# FVA industry sub-group on technical requirements

01.09.2022

# JAMA V4 violation examples of series HUD HMI #1

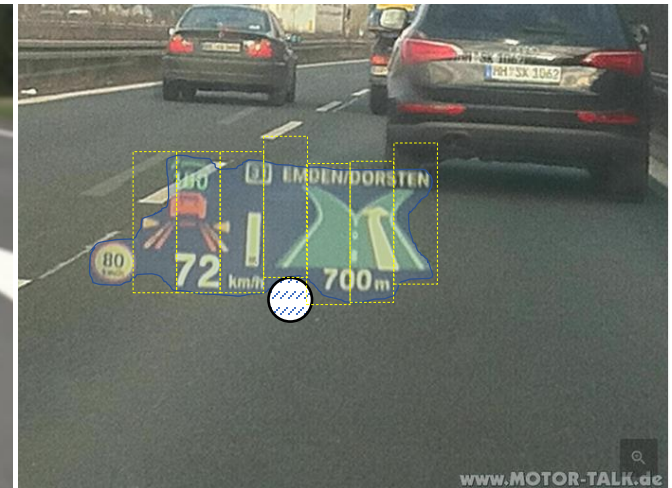
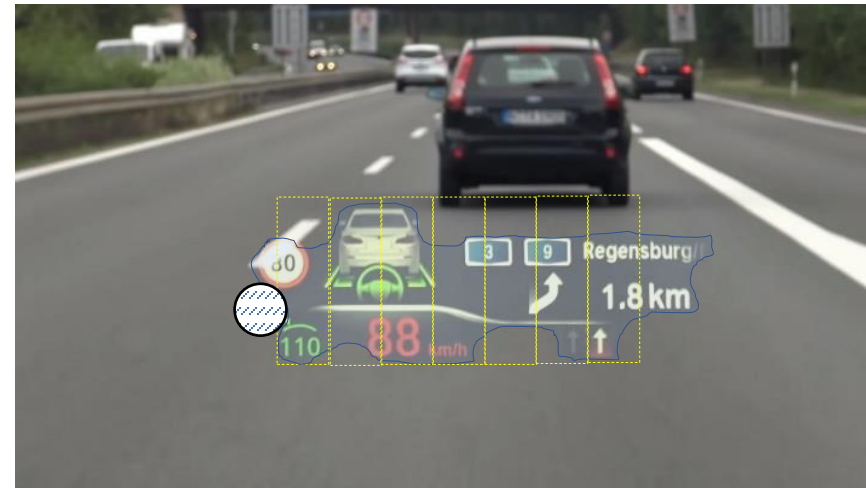
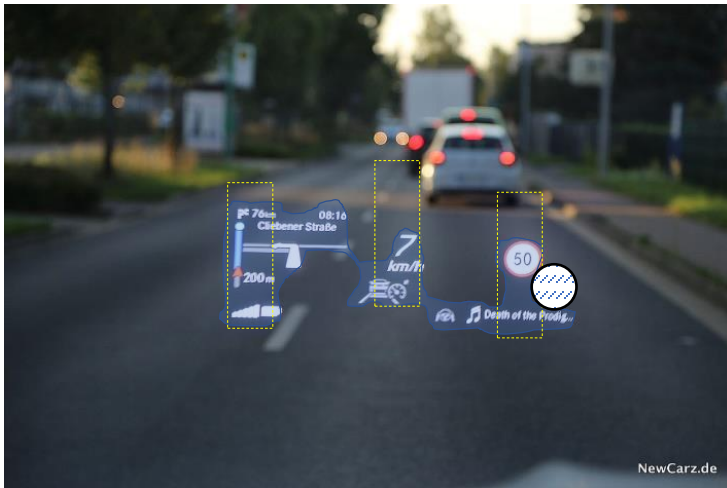
violating JAMA V4 envelope (3x)

violating JAMA V4 envelope (7x)  
violating JAMA V4 red criteria

violating JAMA V4 envelope (7x)

# JAMA V4 violation examples of series HUD HMI #2

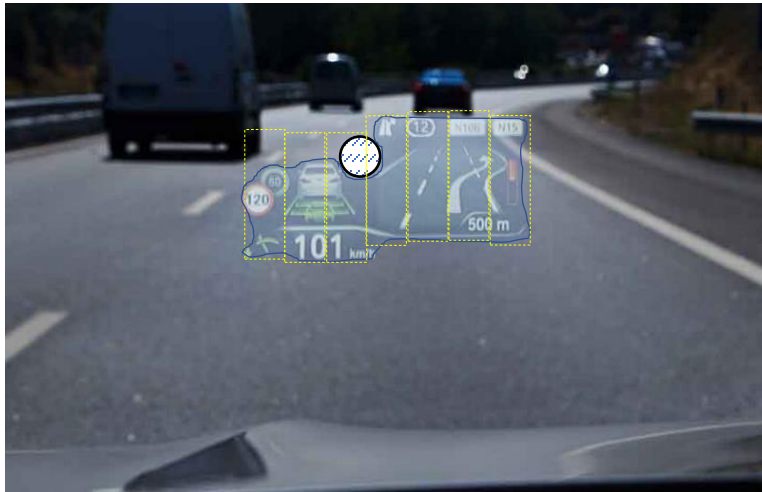
violating JAMA V4 envelope (7x)  
violating JAMA V4 red criteria

violating JAMA V4 envelope (2x)  
violating JAMA V4 red criteria

# questioning the envelope concept in detail

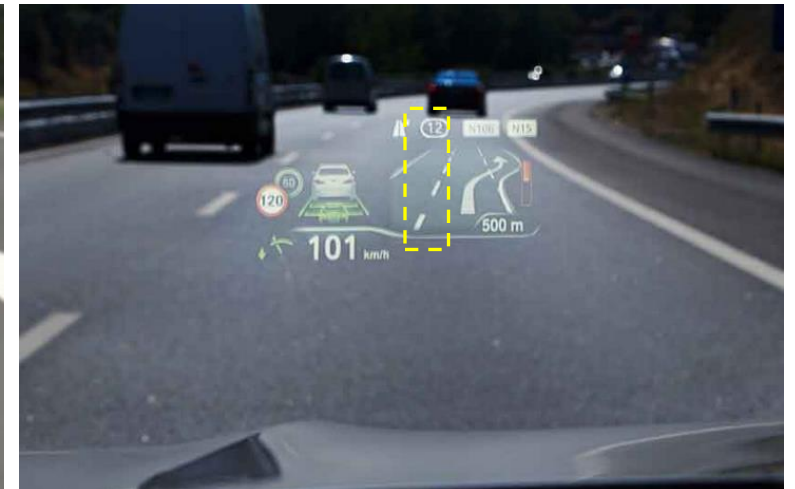
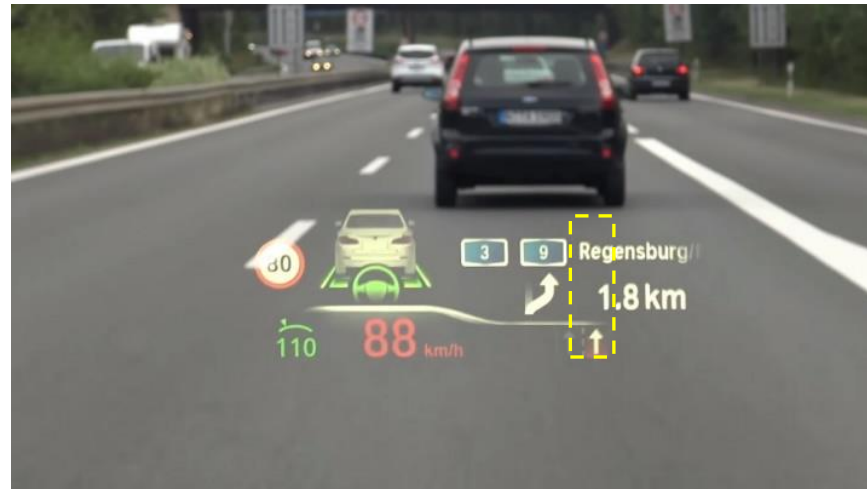
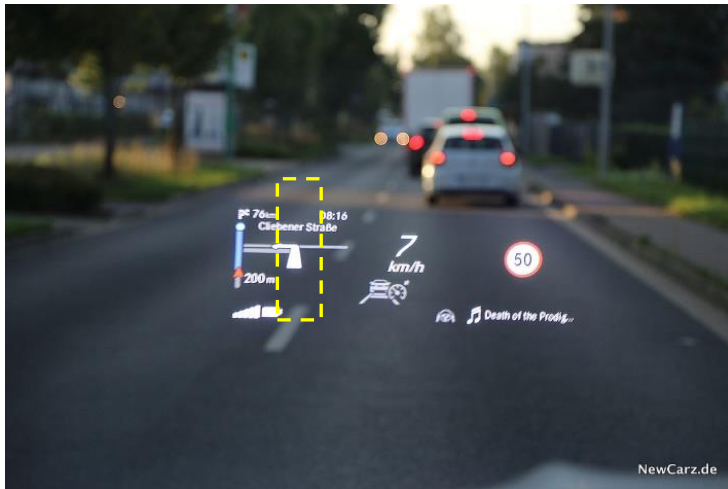
Is it true that with such clean HMI concepts a pedestrian in size of yellow box (basic figure:  $2,6^\circ \times 0,8^\circ$ ) could **not** be seen?

All examples above are static images and do not even consider the relative movement of the car relative to a pedestrian of such size, which will make pedestrians even more recognizable due to constantly changing perspective.

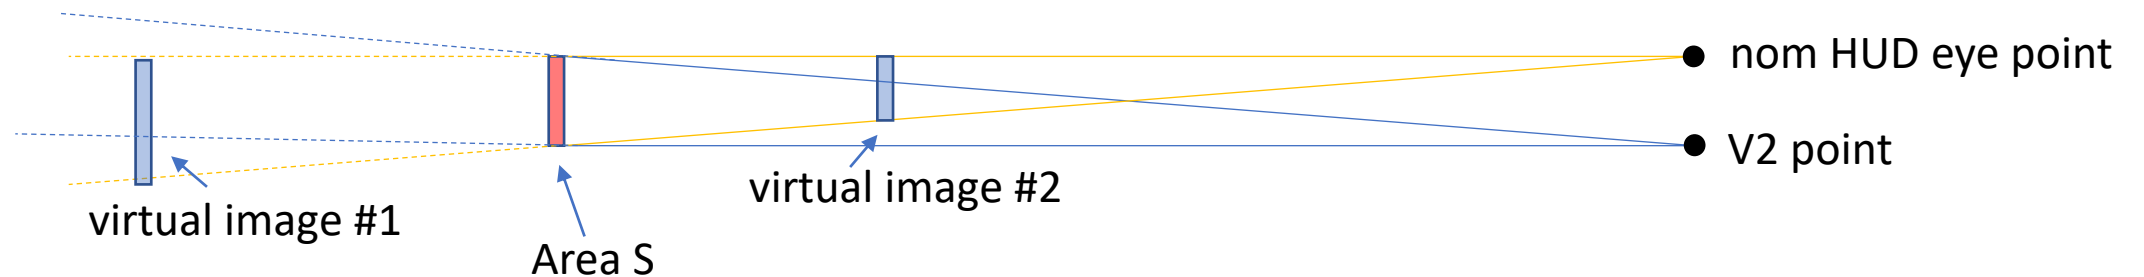
While it is true that the image of a system with lower VID appears higher from V2 point, the behavior of the system when seen from the actual eye point is different. This is happening due to a parallax error.

## CASE 1: large VID

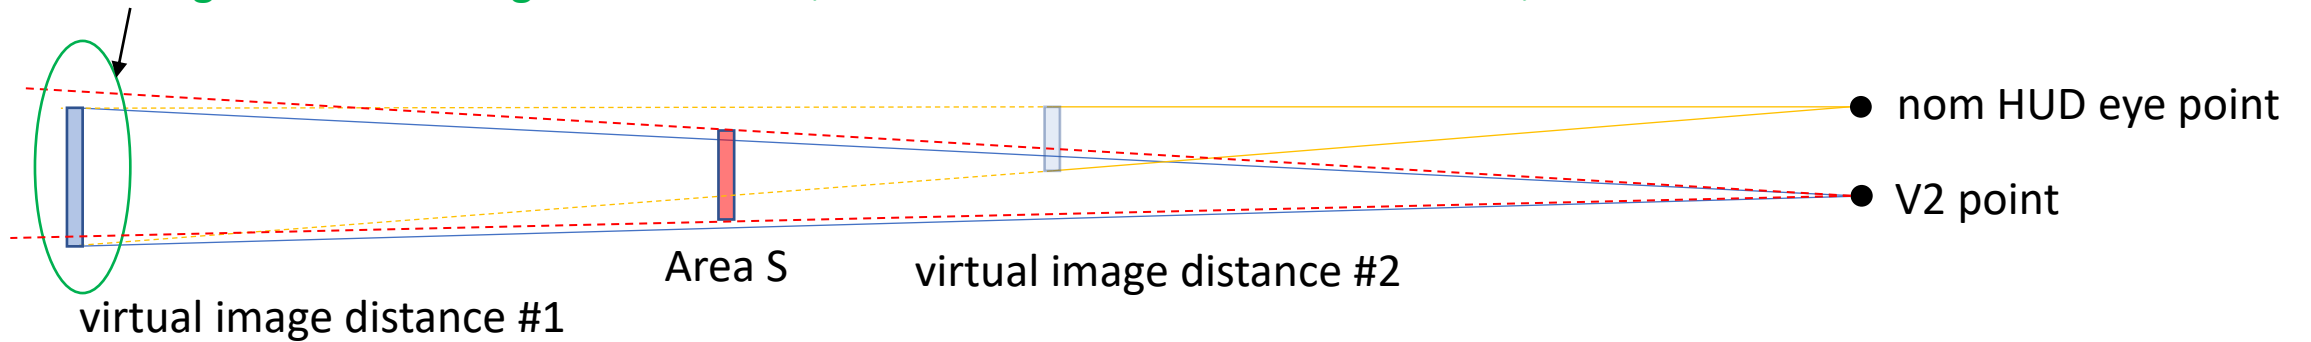
Large VID: VI not regulated as FVA (VI is inside & below Area S when seen from V2)

## CASE 2: small VID

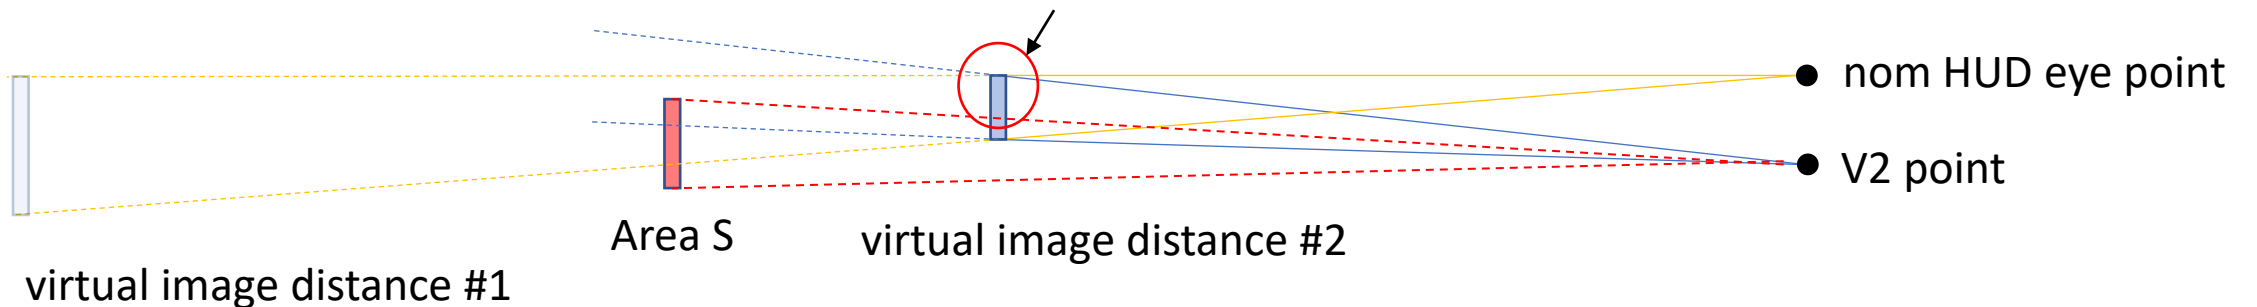
Small VID: 2/3 of VI regulated as FVA (VI is inside and above Area S when seen from V2)

**CASE 3: large VID, less LD angle (typical FVA system), investigated from V2 point** (current regulation)

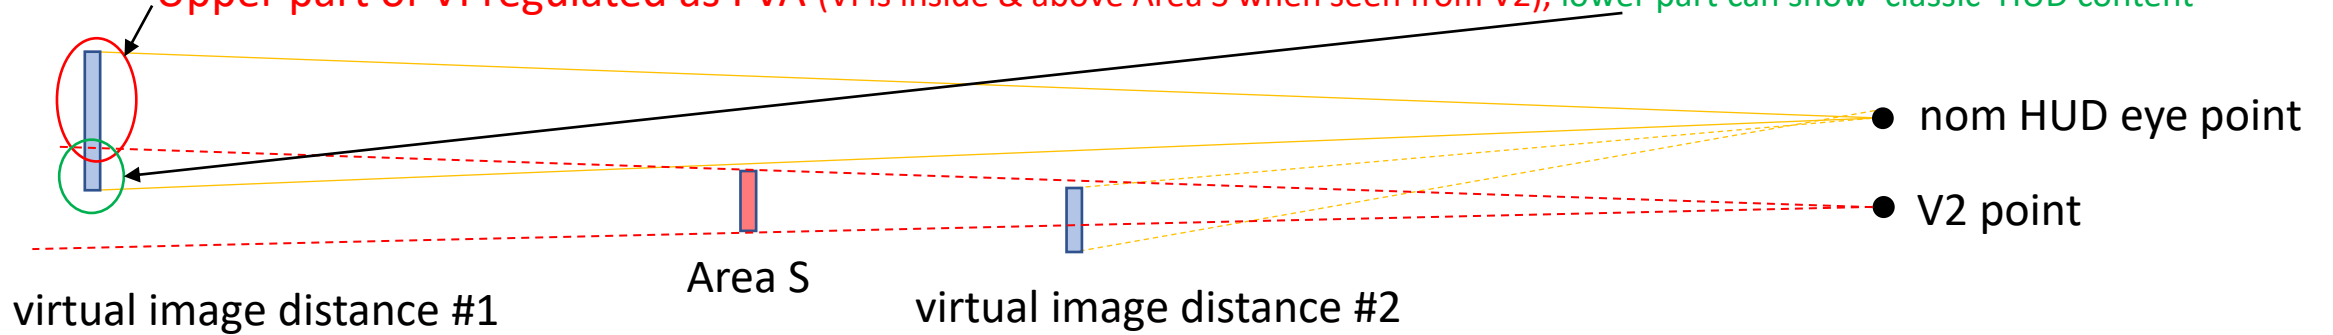
Upper part of VI regulated as FVA (VI is inside & above Area S when seen from V2), lower part can show 'classic' HUD content

Conclusion: Keep the requirement to calculate from V2 point (as currently defined), considering that the parallax error will happen for any object that is not exactly in the same plane (i.e. same distance) as Area S.

**CASE 4: large VID, less LD angle (typical FVA system), but investigated from eyepoint instead of V2**

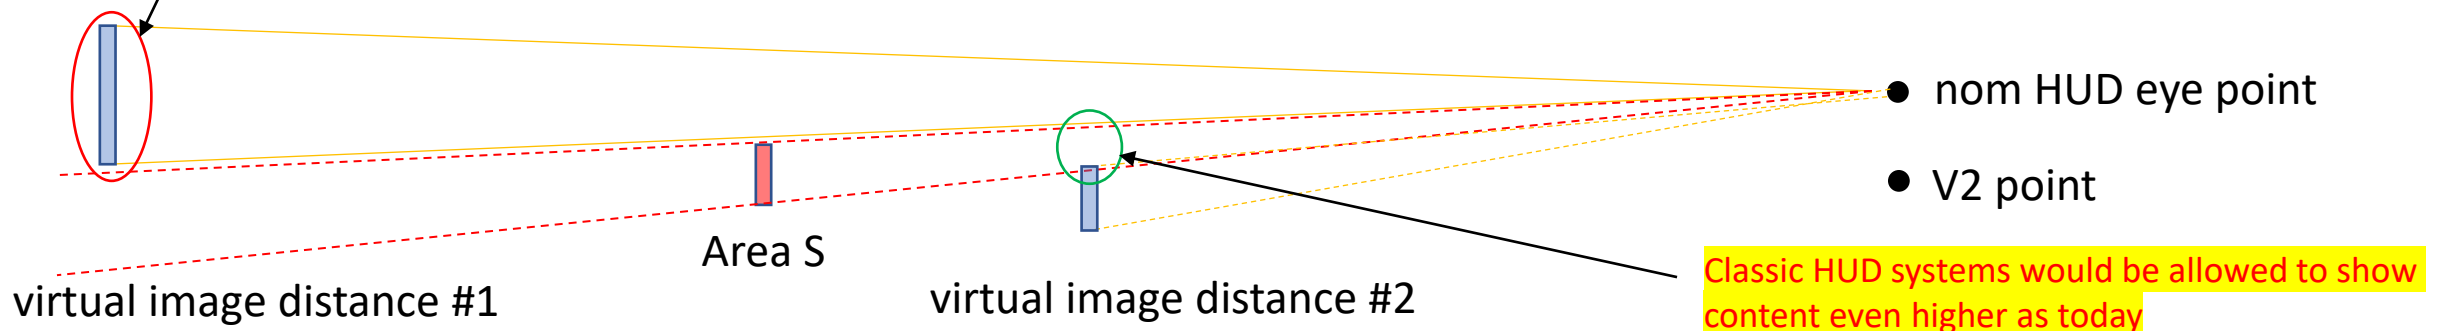
All of VI regulated as FVA (VI is fully above Area S when seen from eyepoint), → 'classic' HUD content in FVA systems would be forbidden
